Subject: Forwarding pictures that Larry provided/ Please see in conjunction with my letter.

Subject: Story Poles/ Incorrect reflection of height/mass in proposed plans 101 Broadway, LG

Top of Block Wall 486.7'—

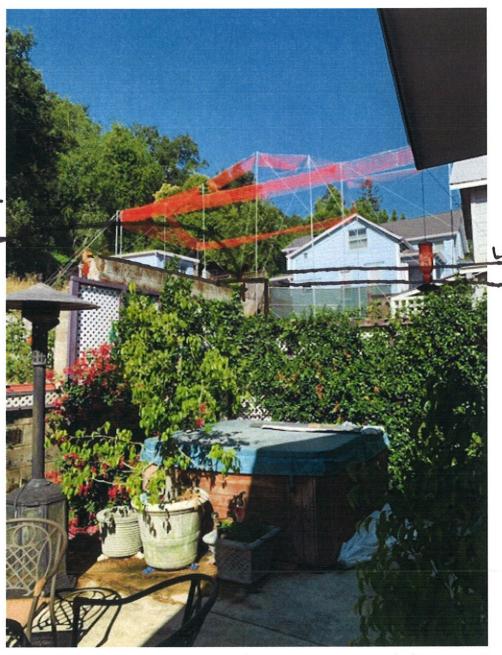
The civil drawing shows the LFF Elevation at 487.0.

It also shows top of East wall behind the Existing House at 483.8.

It shows the top of existing Block Wall between the properties at 486.7.

You can see in our photos the top of the Block Wall.

Actually the LFF is even higher than what I show on my photo drawing sent to Town committee.

I suggest you have the surveyor get an actual elevation of 93 Broadway Main Floor Level at back patio.
